MAINTENANCE INFORMATION FOR MERCEDES-BENZ ACCESSORY UNIT DRIVES WITH TENSIONING ARM 55123

TECHNICAL INFO No. 1081

Image 4: Over-running alternator pulley

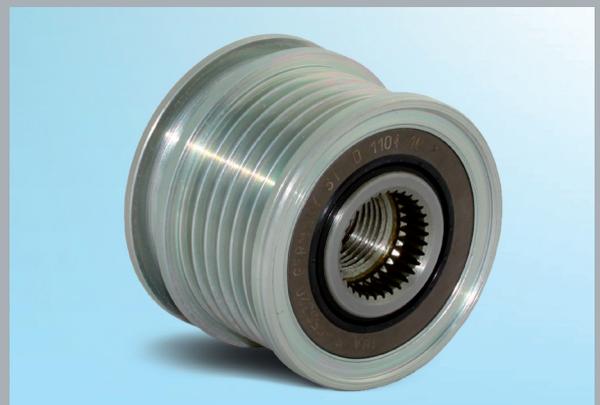
In the vehicles listed above, strong dynamic movements in the accessory unit drive may cause tensioning arm 55123 (image 3) to break. This may be caused by a worn or defective over-running alternator pulley. As a result of this, the entire accessory unit drive will fail, causing the vehicle to break down. To prevent damage, RUVILLE therefore recommends that the over-running alternator pulley (image 4) be checked and replaced if necessary.
